Office Action Summary	Application No. 10/578,001	Applicant(s) YAMAZAKI ET AL.	
	Examiner MOHAMMAD Timor KARIMY	Art Unit 2894

DETAILED ACTION

FIG. 5

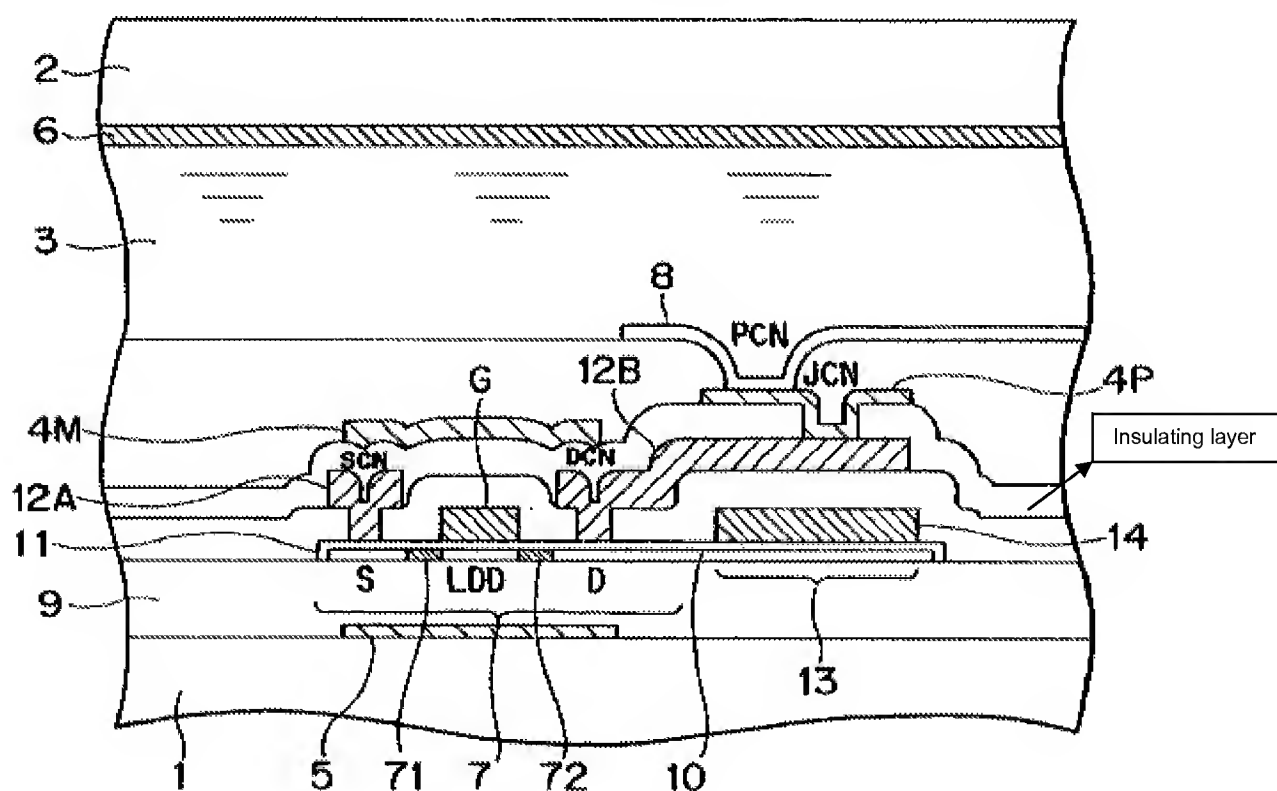
With respect to claim 1, Hashimoto discloses in figures 1-7, a thin film transistor comprising:

an insulating layer (see Fig. 5 below) having a first opening;

a first conductive layer 12B in the first opening;

a second conductive layer 4p on and in contact with the first insulating layer and the first conductive layer 12B;

wherein the first conductive layer 12B is **wider and thicker** than the second conductive layer 4p.

With respect to claim 10, Hashimoto implicitly teaches in Fig. 5 the thin film transistor of claim 1, wherein the thin film transistor further comprises a light

shielding film 5 below the first conductive layer 12B (Hashimoto teaches titanium as the material for a similar light shield film in Para [0005]).

With respect to claim 19, Hashimoto implicitly teaches in Fig. 5 the thin film transistor of claim 1, wherein a television apparatus can include the thin film transistor of claim 2.

With respect to claim 2, Hashimoto discloses in figures 1-7, a thin film transistor comprising:

- an insulating layer (see Fig. 5 above) having a first opening;

- a first conductive layer 12B in the first opening;

- a second conductive layer 4p on and in contact with the first insulating layer and the first conductive layer 12B;

wherein the first conductive layer 12B is **wider and thicker** than the second conductive layer 4p.
